ADDENDUM NO. 7

HVAC & CONTROLS REPLACEMENT/ADDITION AT NINE (9) SITES: BARRANCA, BEN LOMOND, CYPRESS, GROVECENTER, MANZANITA, MERWIN, MESA, ROWLAND, AND WORKMAN ELEMENTARY SCHOOLS RFQ/RFP #22-23-105

January 19, 2023

M1.1C

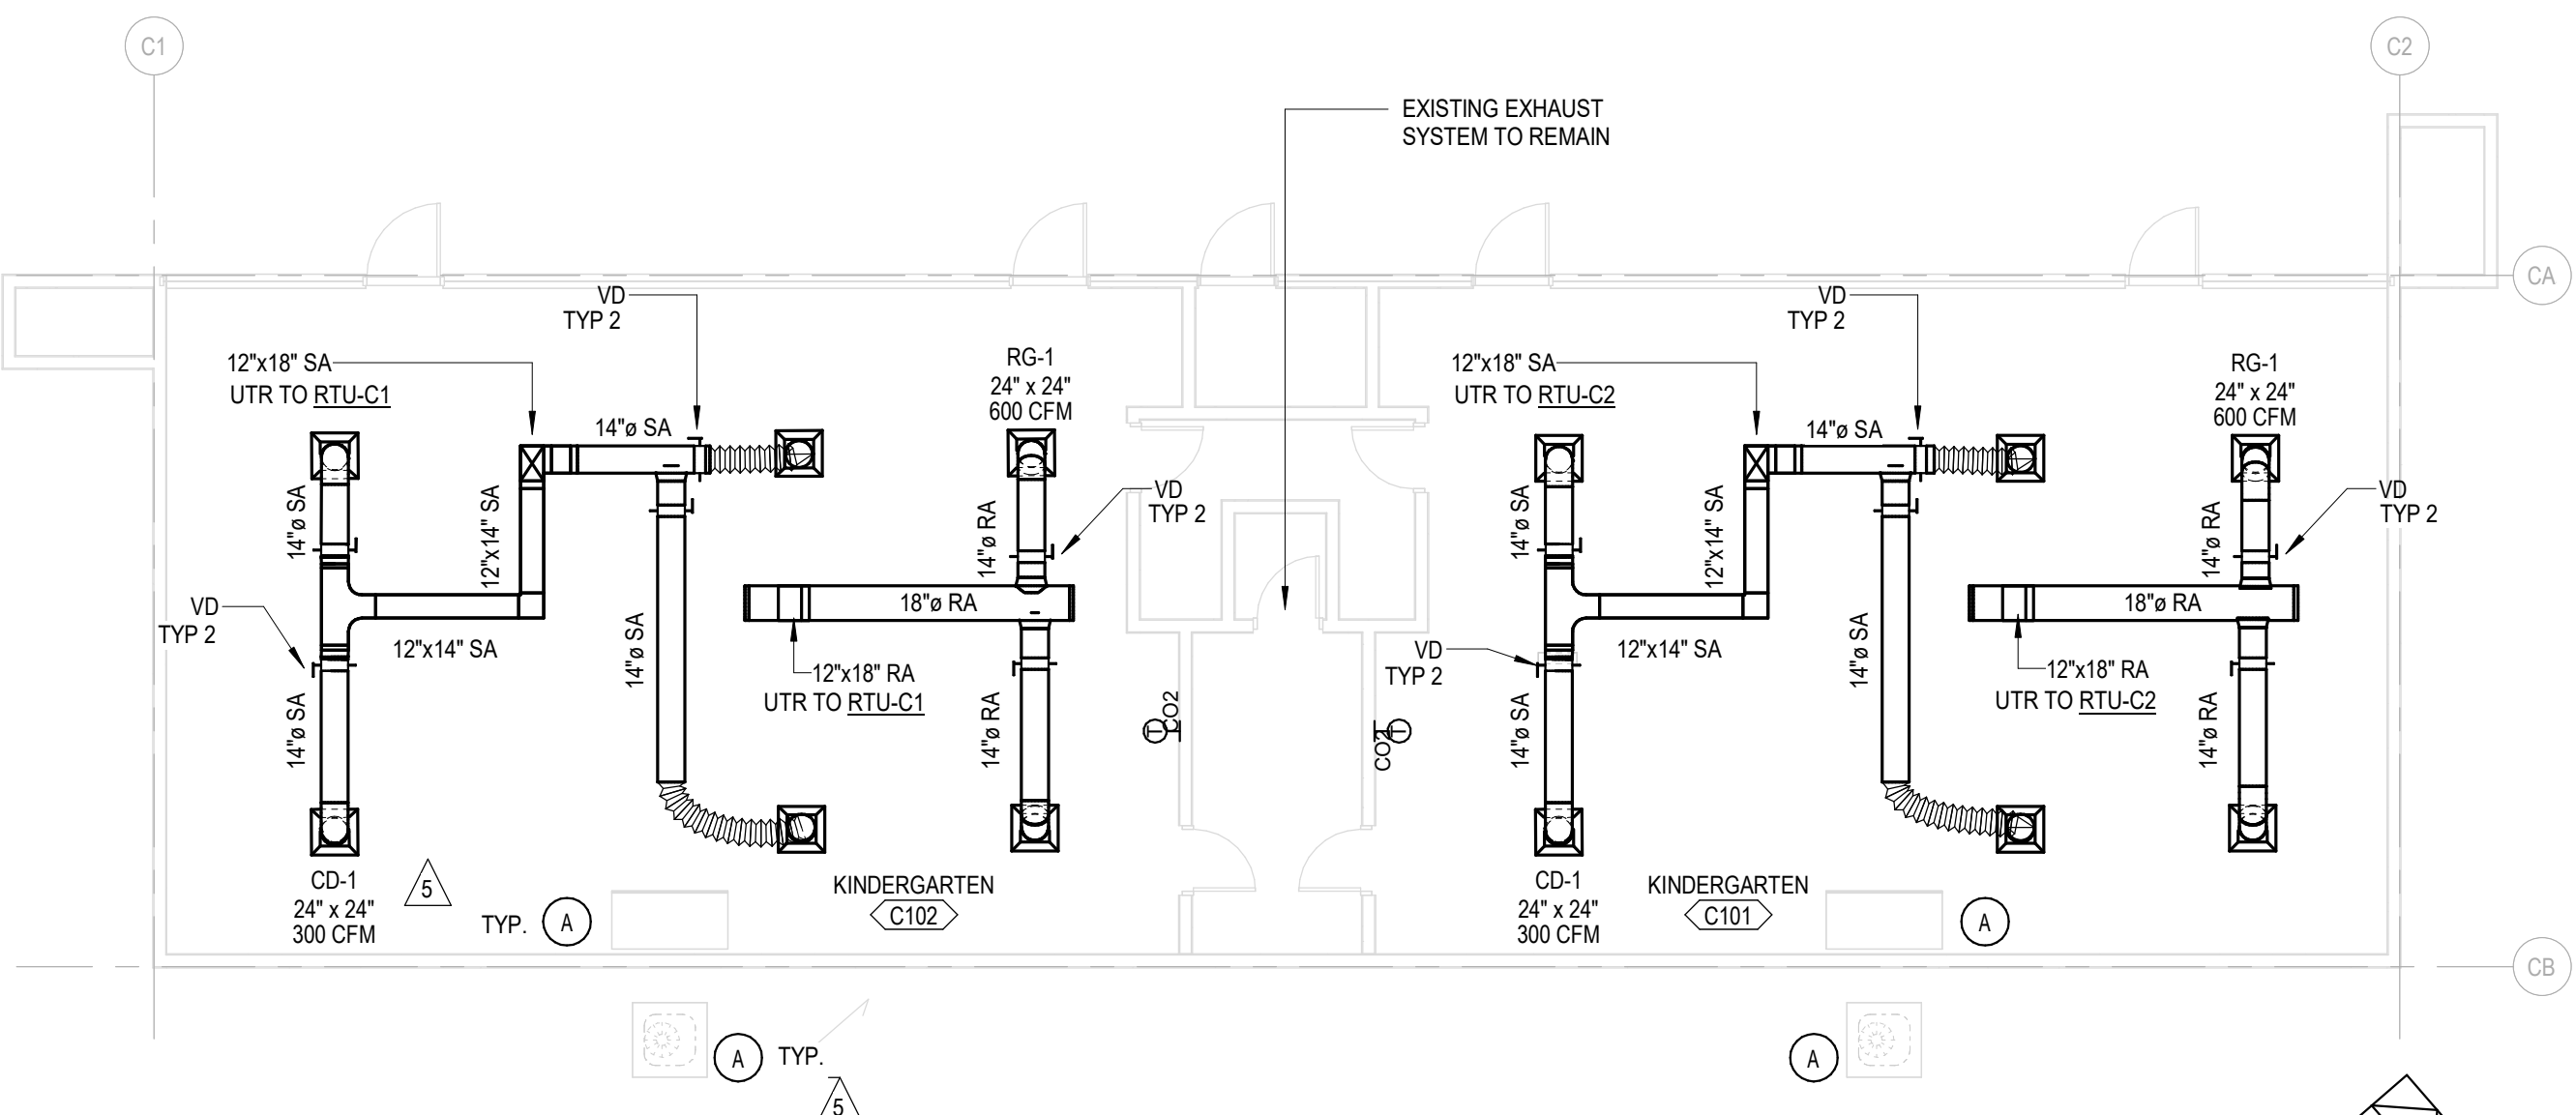
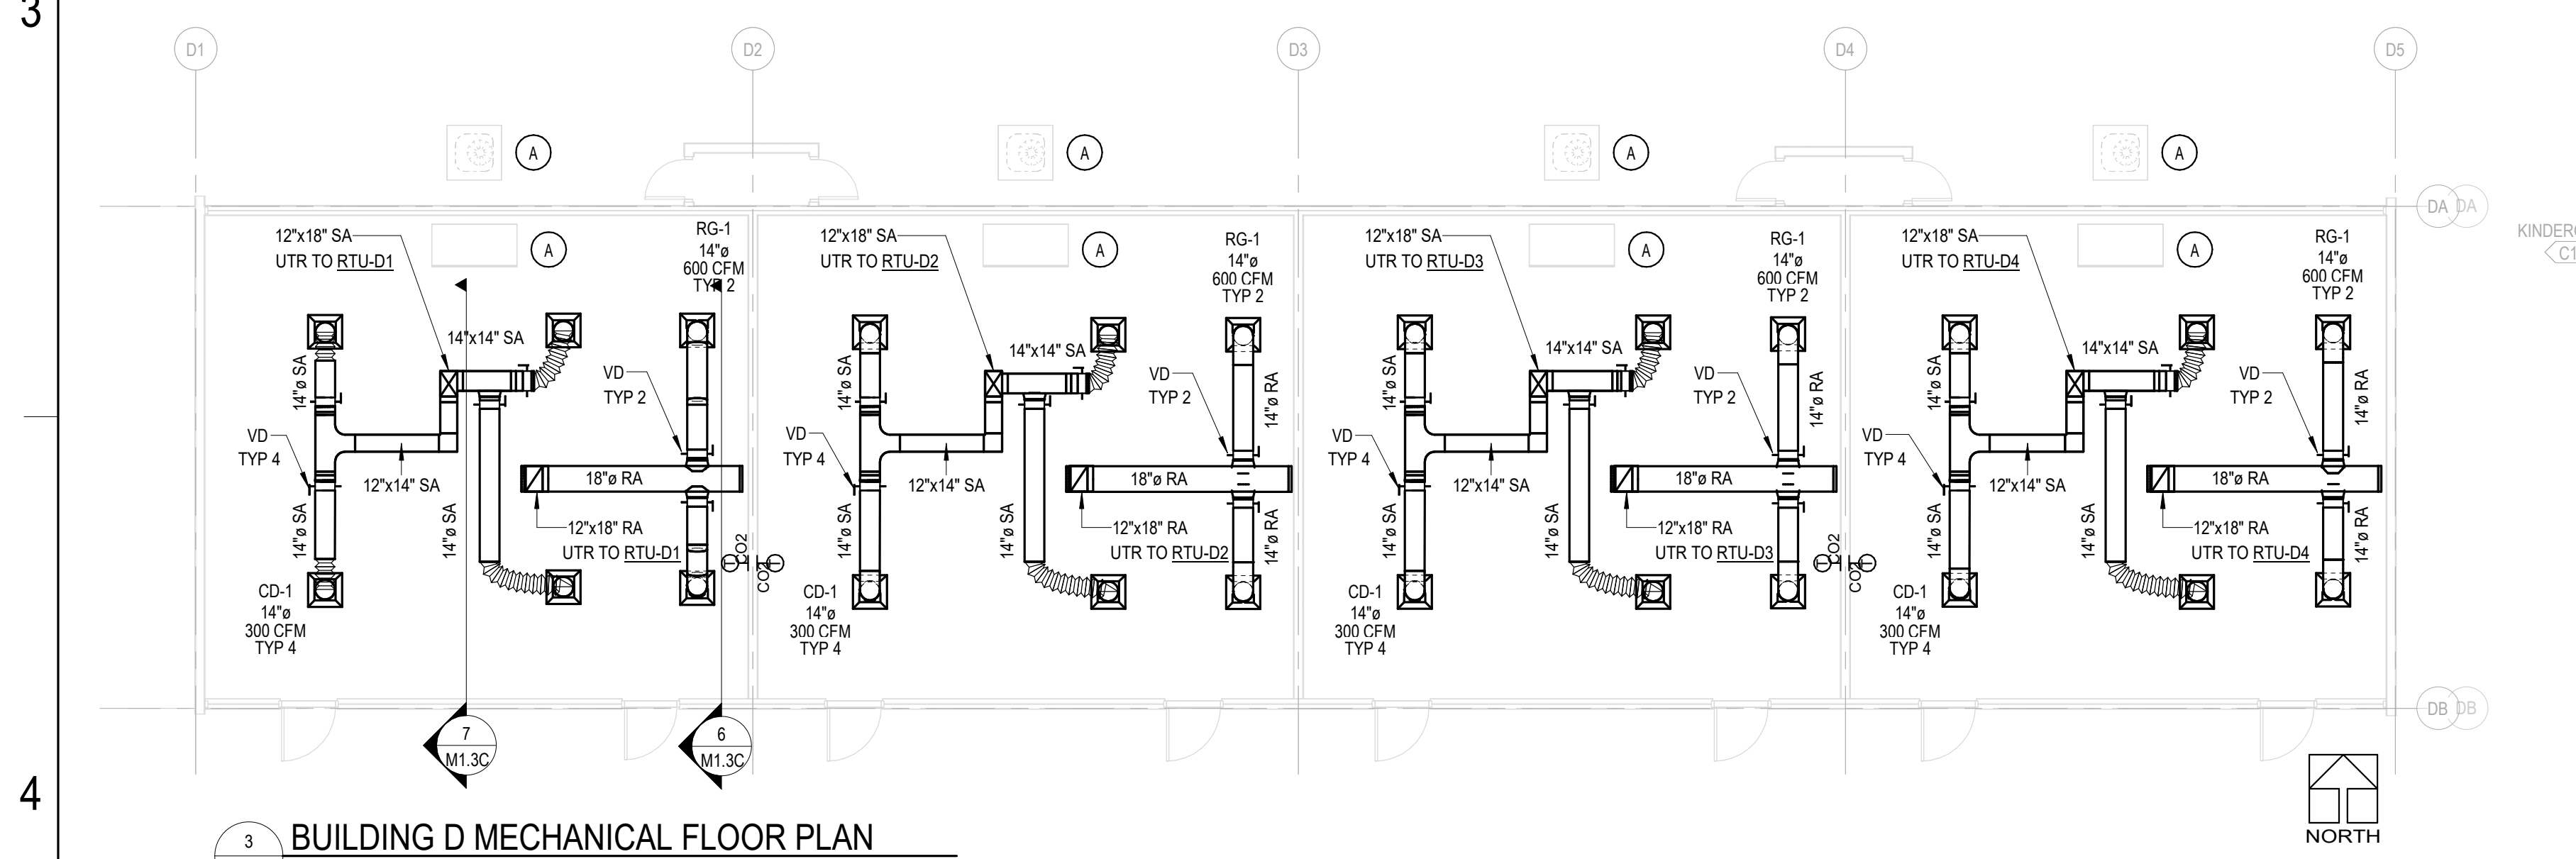
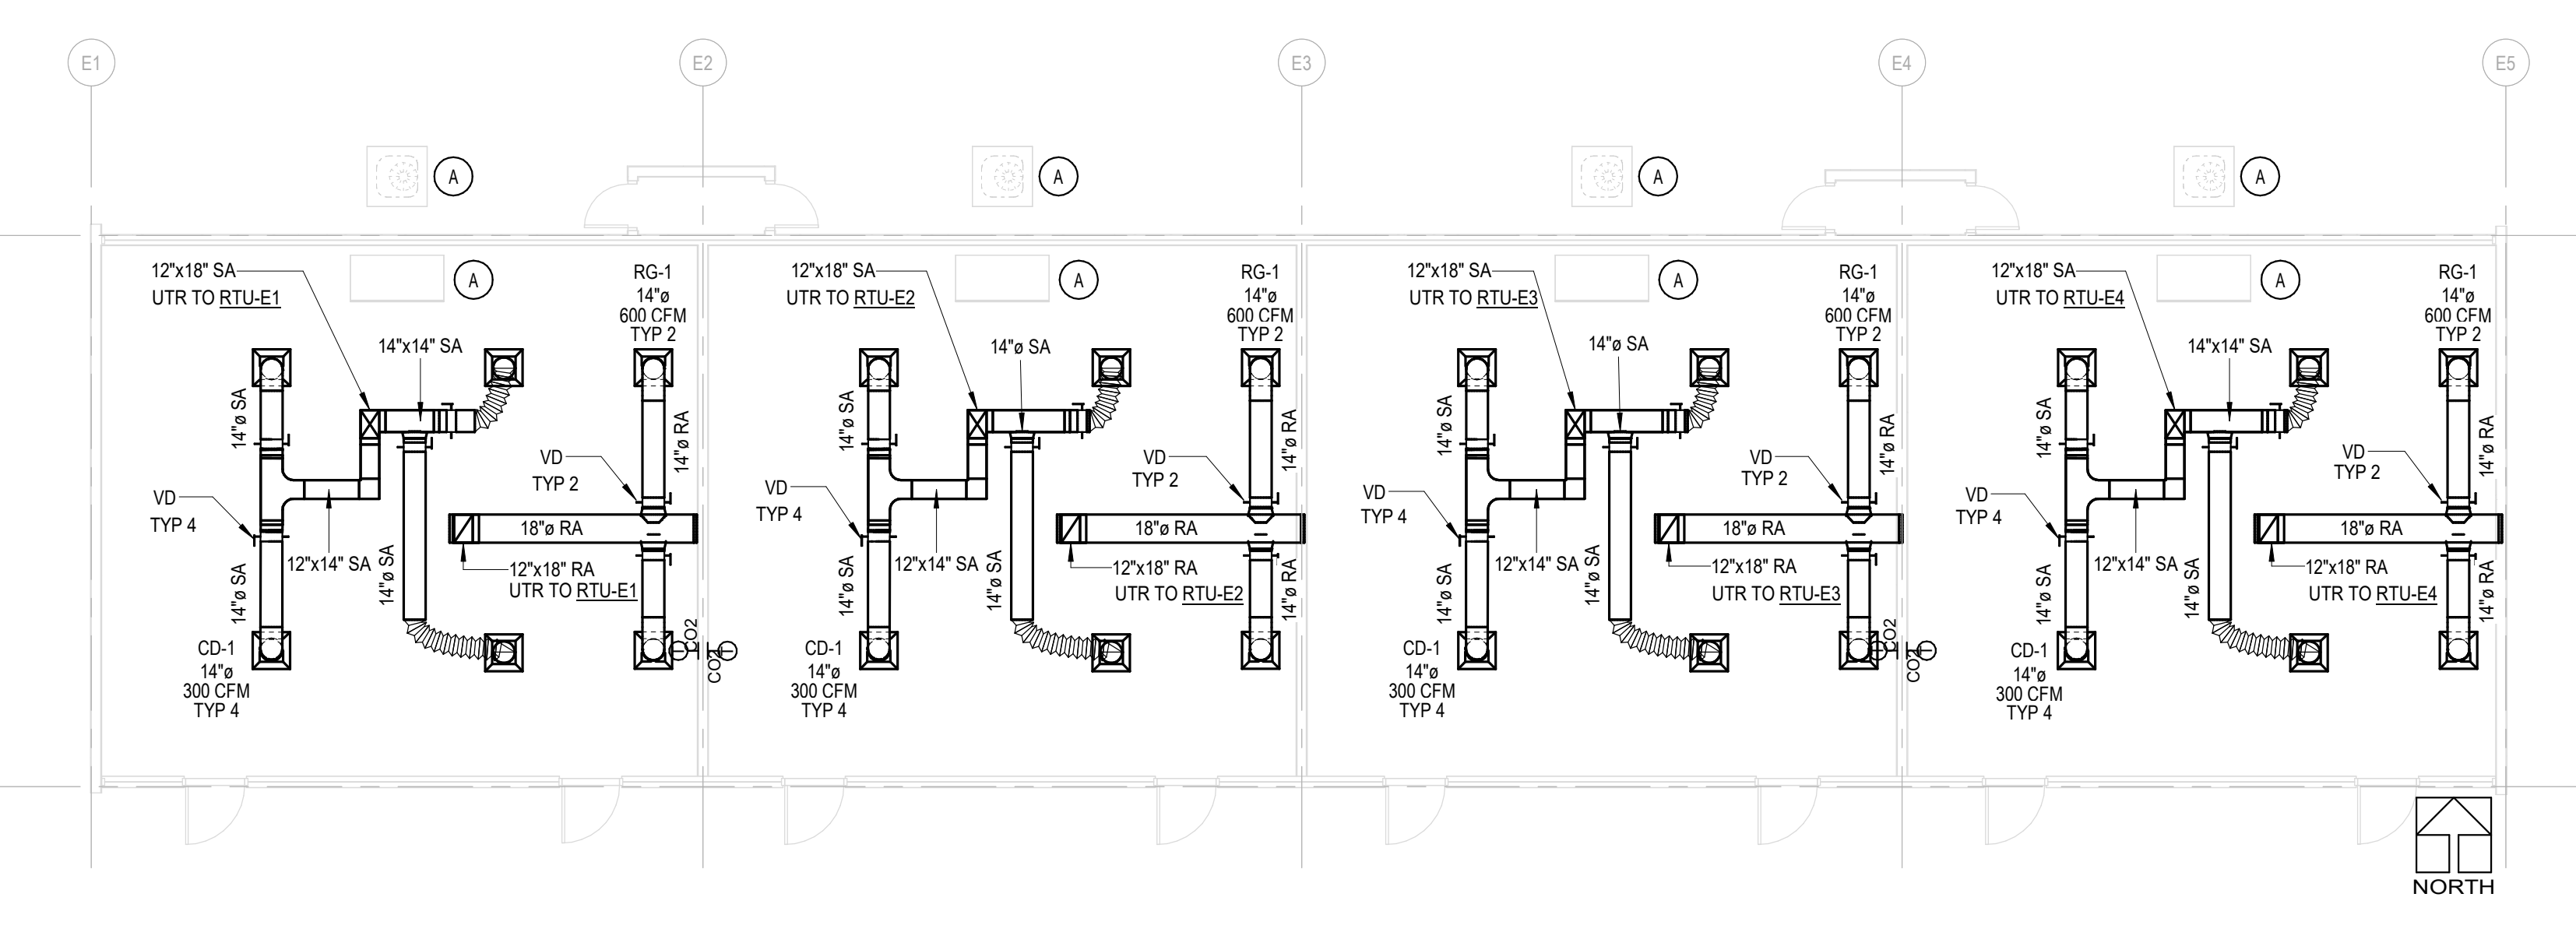
(Page M1.1C)

-Building F: GL F3- There is an extra set of Co2/T-Stat per the plans. Please confirm if RTU F2 and RTU F3 Co2s/T-stats are to be on GL F2 and F4 walls.

DLR Response: See attached updated drawing M1.1C
